Special Meeting of the Economic Development Commission (EDC)

REPORT TO THE ECONOMIC DEVELOPMENT COMMISSION

Site Plan Amendment

Project Name:	Central Aquatics
Project Location:	5401 W. Oakwood Park Drive
Property Owner:	Central Aquatics, A Central Garden & Pet Company
Applicant:	Pinnacle Engineering Group
Agent:	Aaron Koch, Pinnacle Engineering Group
Current Zoning:	Planned Development District No. 7, Franklin Industrial Park
2025 Comprehensive Plan:	Commercial
Use of Surrounding Properties:	Industrial properties to the north and west, vacant developable property within the Franklin Business Park (Planned Development District No. 18) to the east, and single family residential development to the south
Applicant's Action Requested:	Approval of the Site Plan Amendment

GRADING, EROSION CONTROL & PAVING PLAN

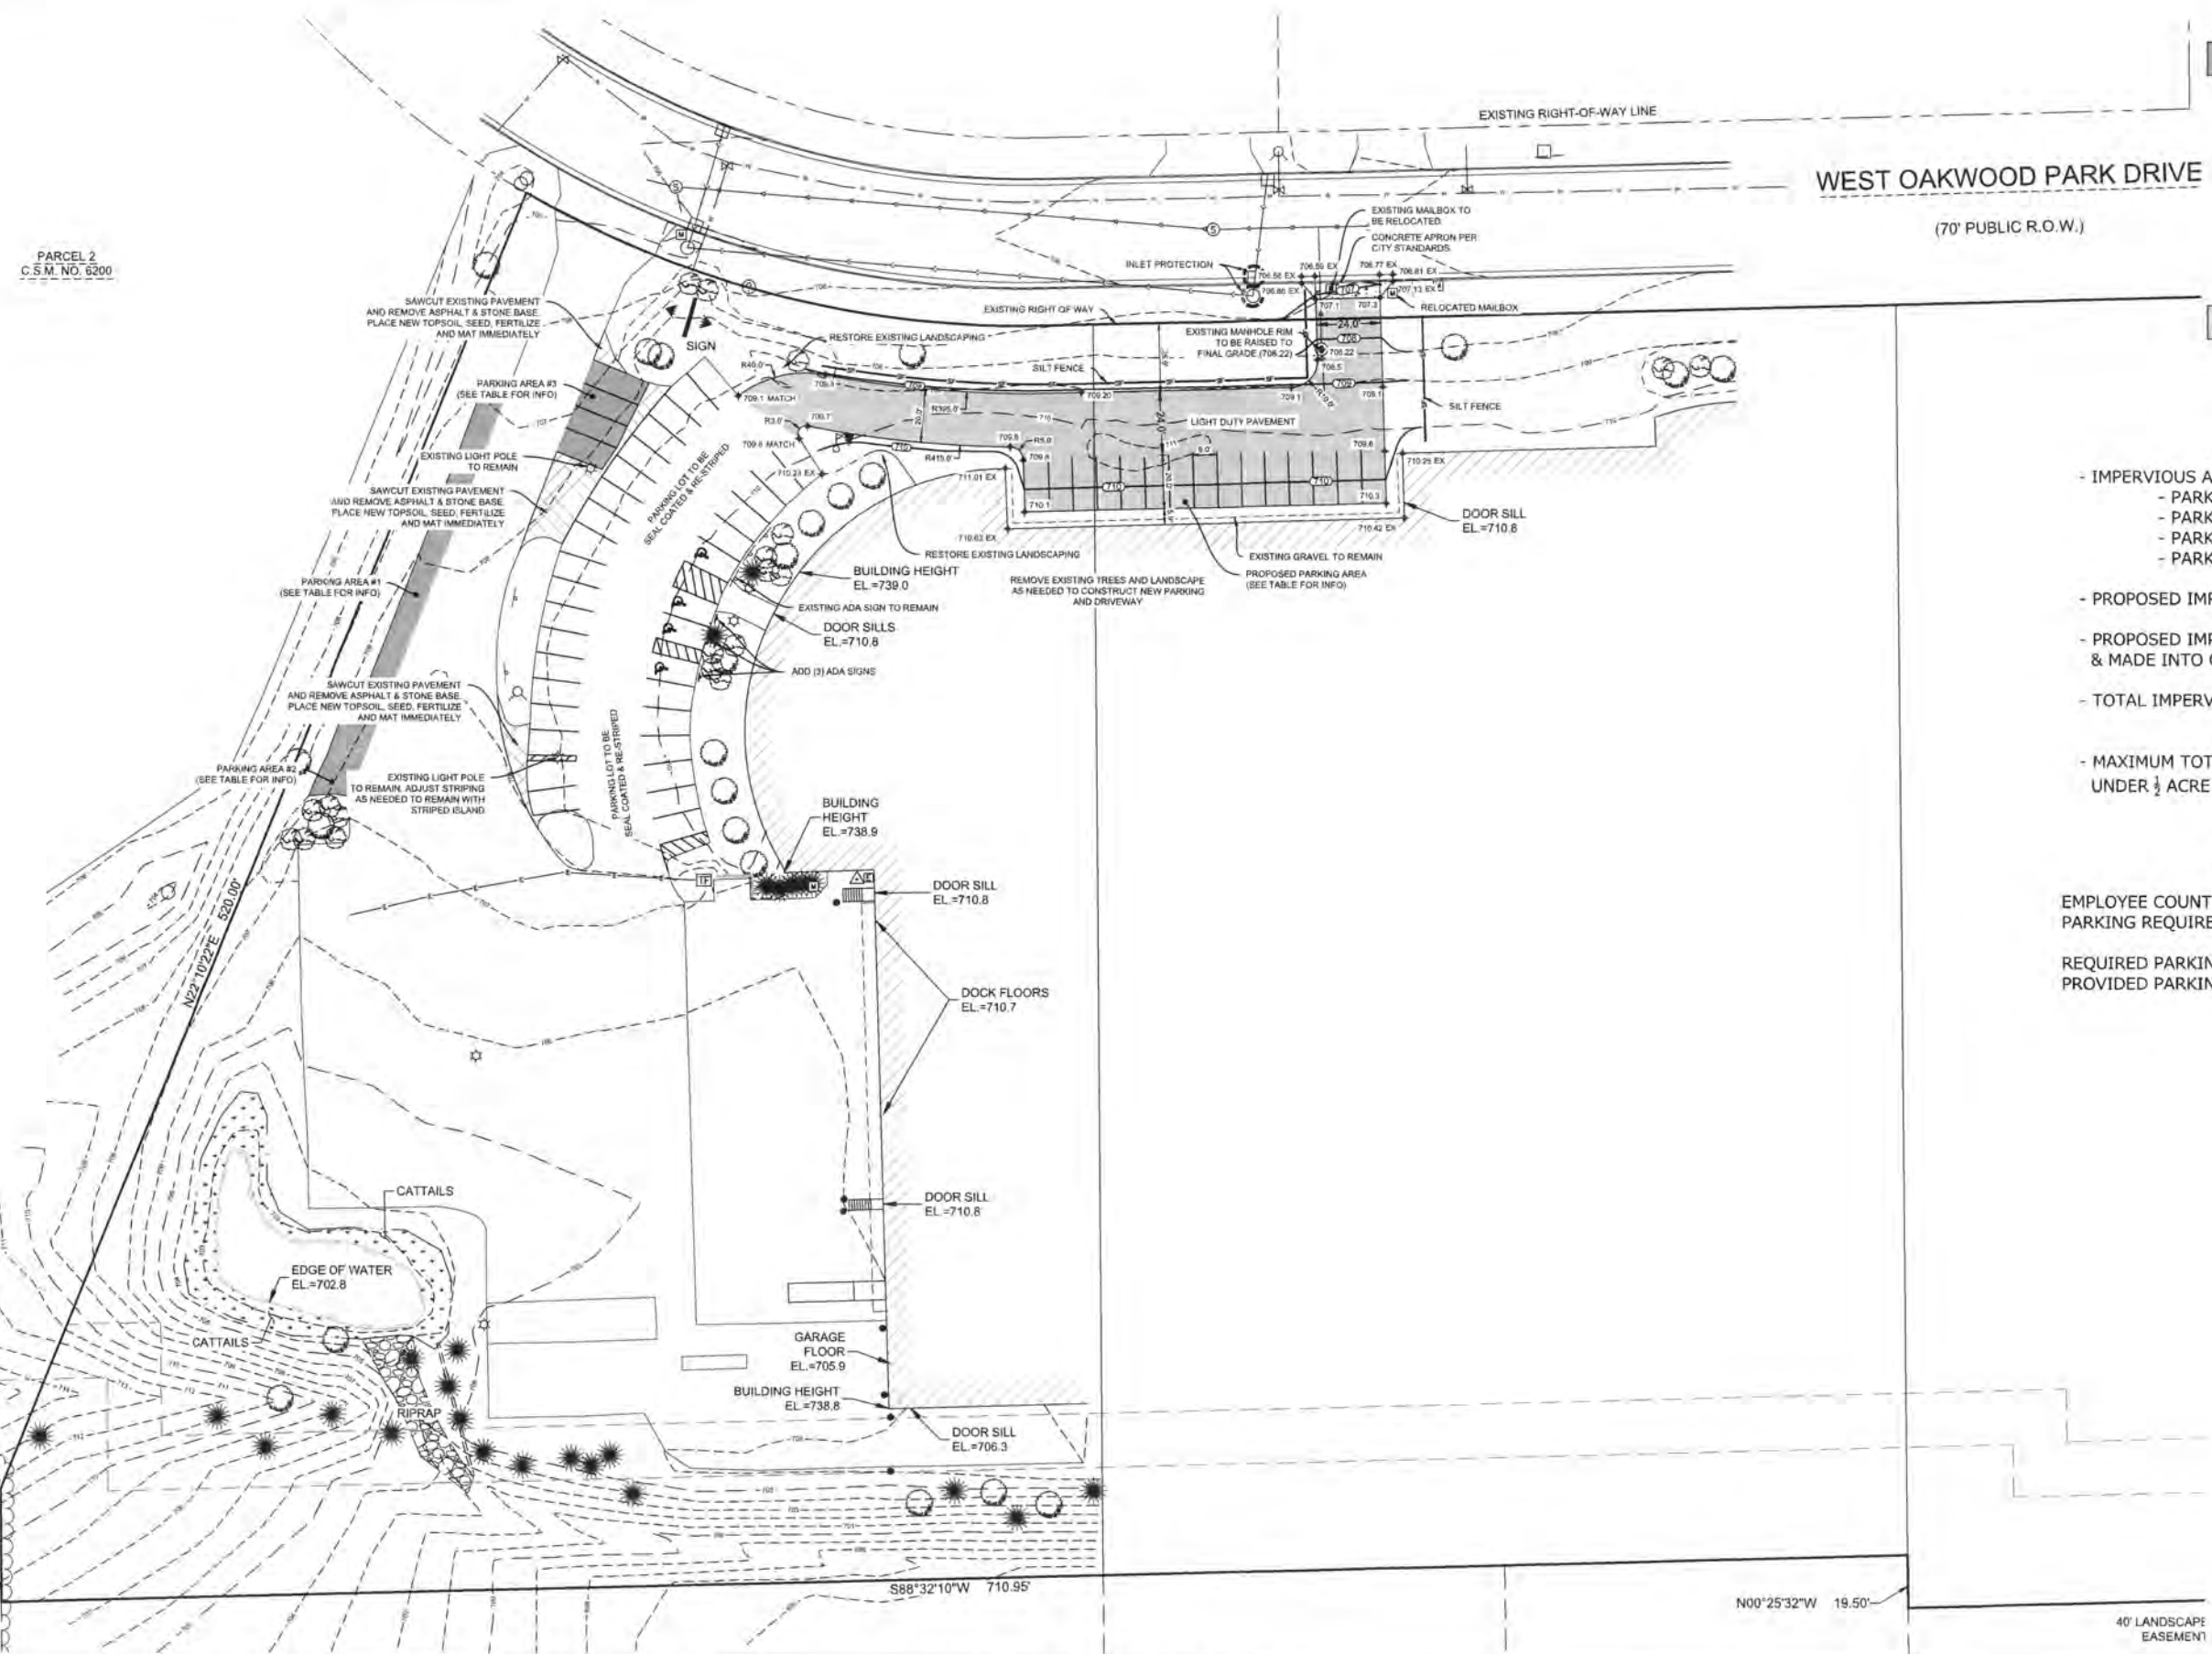
The applicant has provided a Grading, Erosion Control & Paving Plan which highlights the parking lot changes adjacent to the northwest corner of the subject building, and has provided a Landscape

It is important to note that the proposed parking lot addition, in combination with the unapproved parking lot addition in 2014/2015, and an approved parking lot addition in 2006, has resulted in an increase of impervious surfaces of more than one-half acre. As such, Milwaukee Metropolitan Sewerage District (MMSD) standards require installation of stormwater management practices.

As the applicant does not wish to install any stormwater management facilities, the applicant has proposed to remove approximately 1,000 square feet of impervious surfaces within the existing parking lot to remain under the one-half acre impervious surface threshold of the MMSD. However, the Assistant City Engineer has indicated:

“[H]ere is what they’ll need to submit to verify they are under the half-acre threshold for storm water management:

- An aerial from September 2001. On that aerial they will need to draw/trace as close as possible the existing (at that time) impervious area including gravel (building, driveway, parking, etc.). They will need to find the area (square feet) and clearly note it on the aerial.
- A proposed plan that needs to include a survey of all existing impervious area on the site as well as depiction of proposed impervious area. The square footage of that area needs to be noted on the exhibit.”

Therefore, staff recommends that the applicant shall submit to the Engineering Department for review and approval, the Milwaukee Metropolitan Sewerage District required impervious surface/storm water management calculations and exhibits, prior to construction of the proposed parking lot addition.

5. The applicant shall submit to the Engineering Department for review and approval, the Milwaukee Metropolitan Sewerage District required impervious surface/storm water management calculations and exhibits, prior to construction of the proposed parking lot addition.

LANDSCAPE PLAN

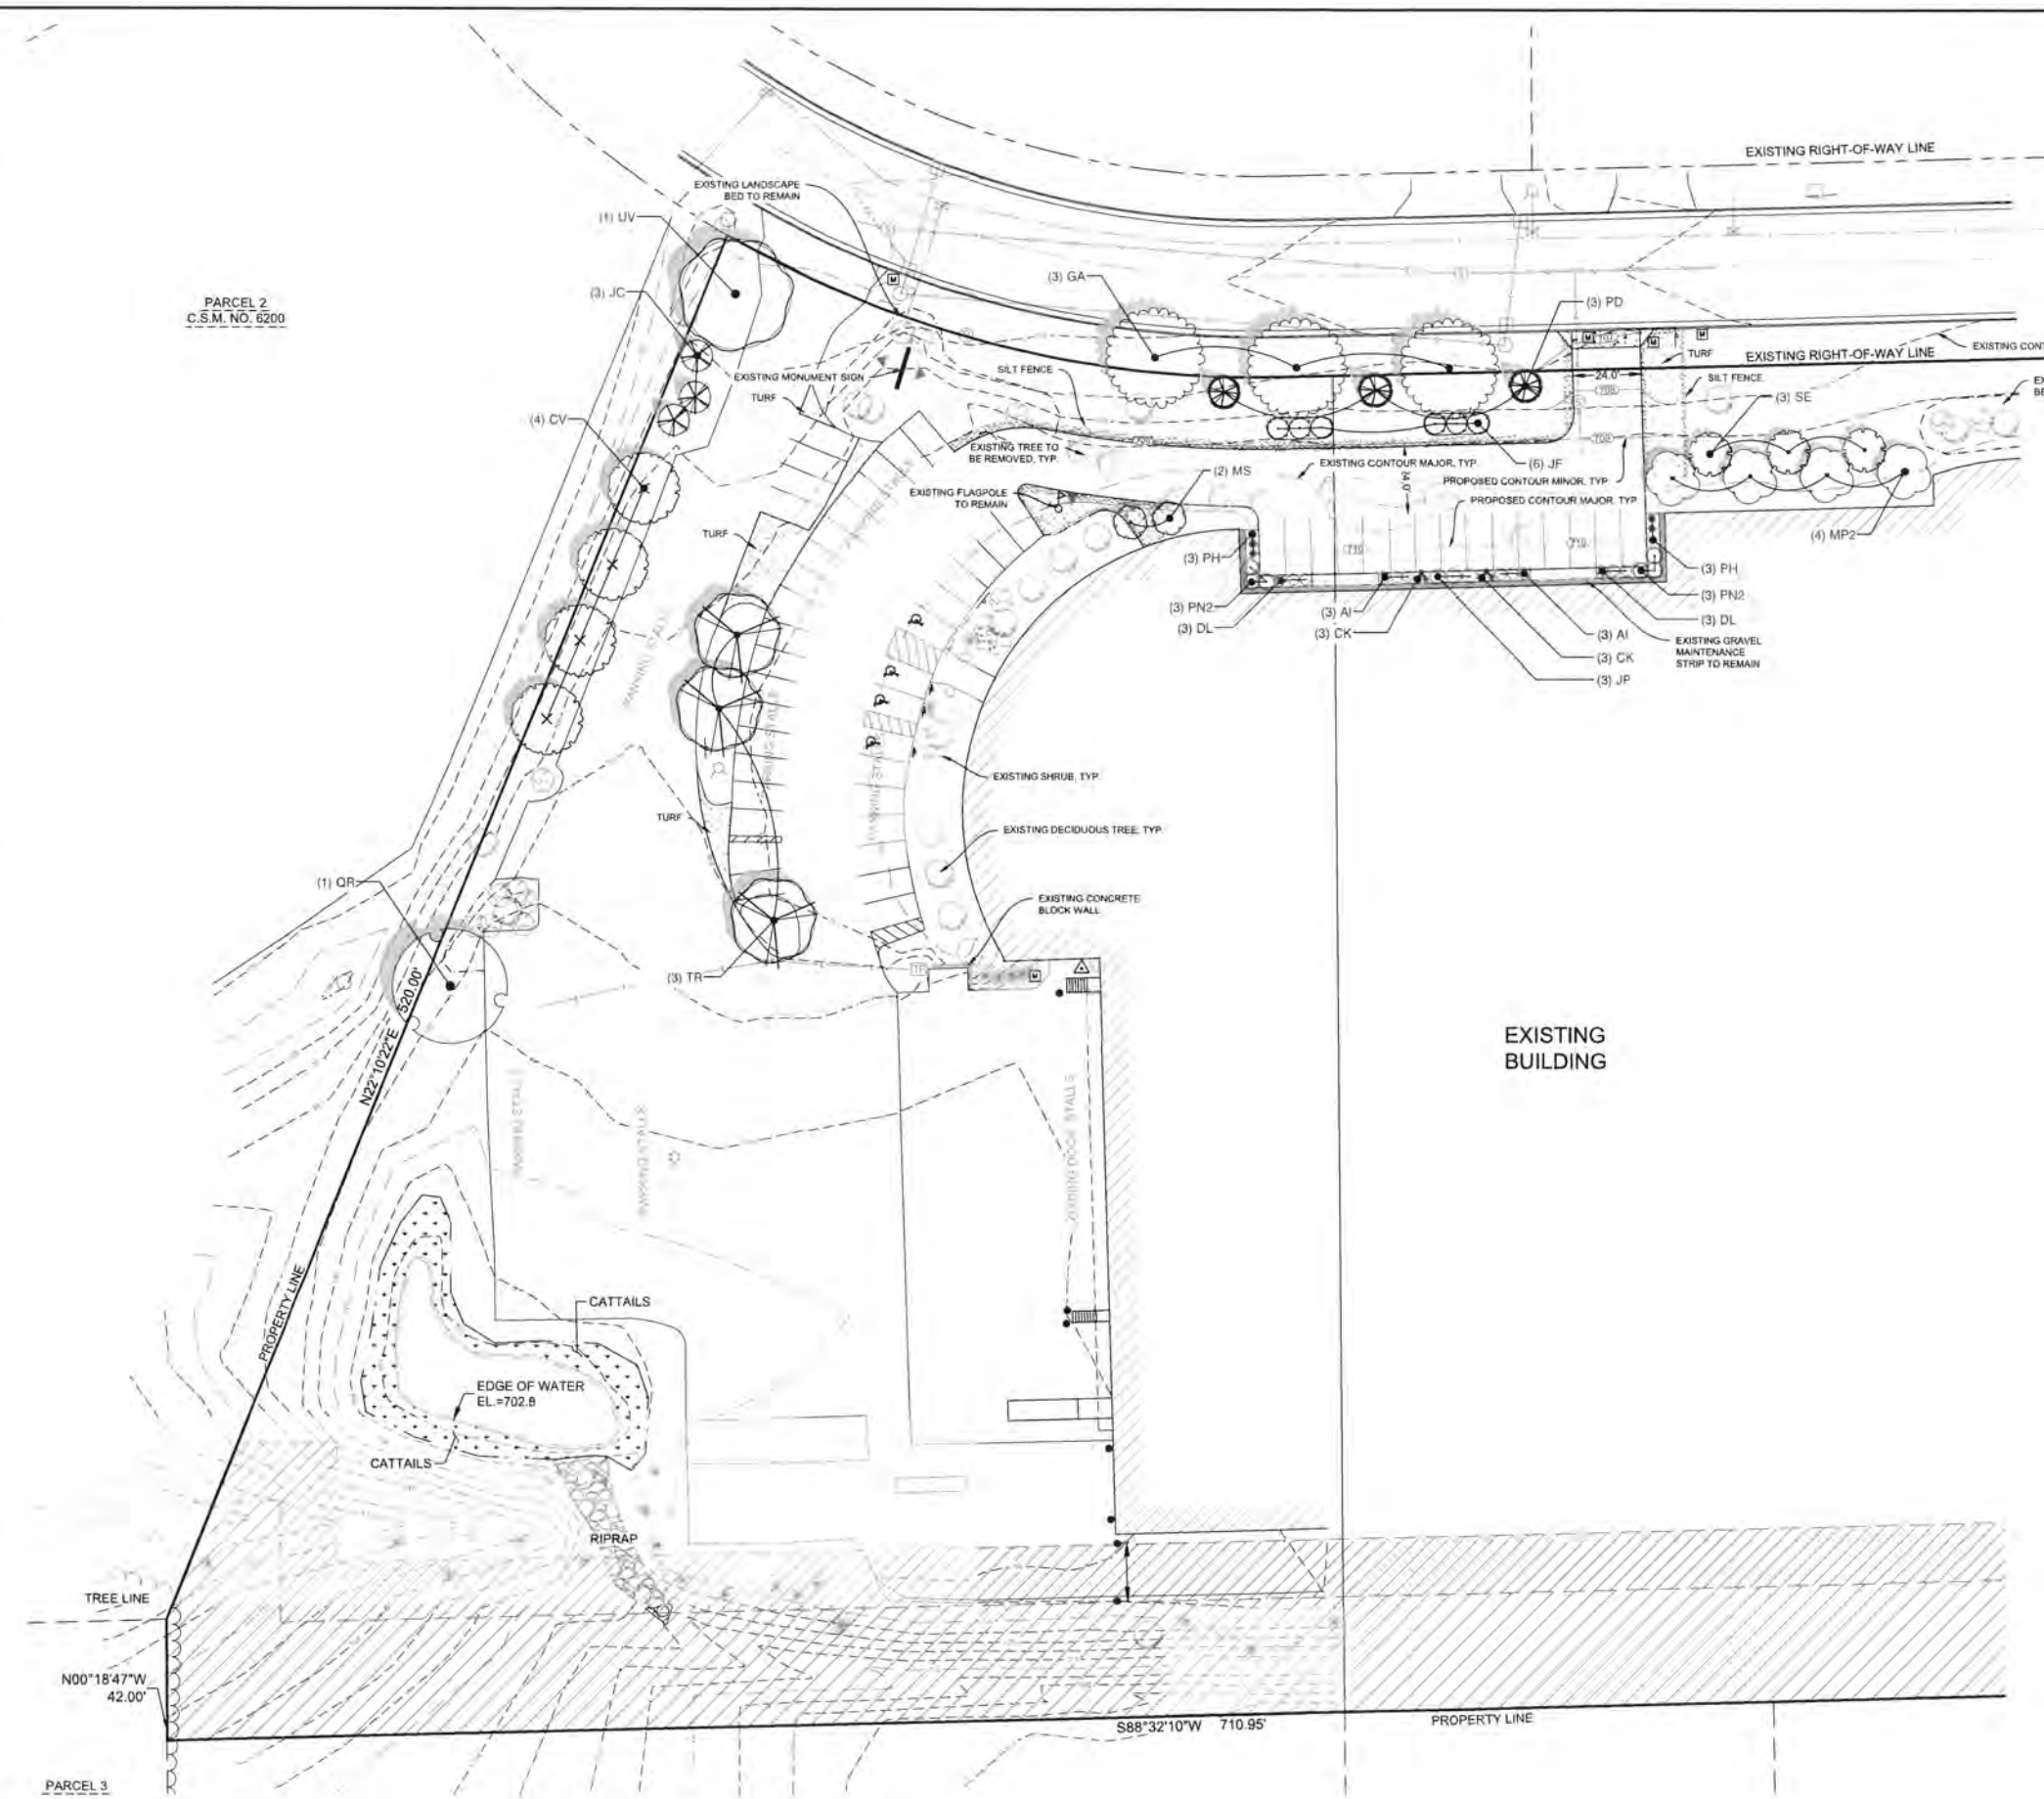
Plan which identifies the existing and proposed landscaping adjacent to the northwest corner of the building.

Staff has reviewed those plans and has no objection to the proposed landscaping changes.

However, it appears it may be too late in the season to plant the proposed landscaping this year. Therefore, staff recommends that the applicant shall install all landscaping as set forth in the subject Landscape Plan, for Department of City Development review and approval prior to June 1, 2019.

4. The applicant shall install all landscaping as set forth in the subject Landscape Plan, for Department of City Development review and approval, prior to June 1, 2019.
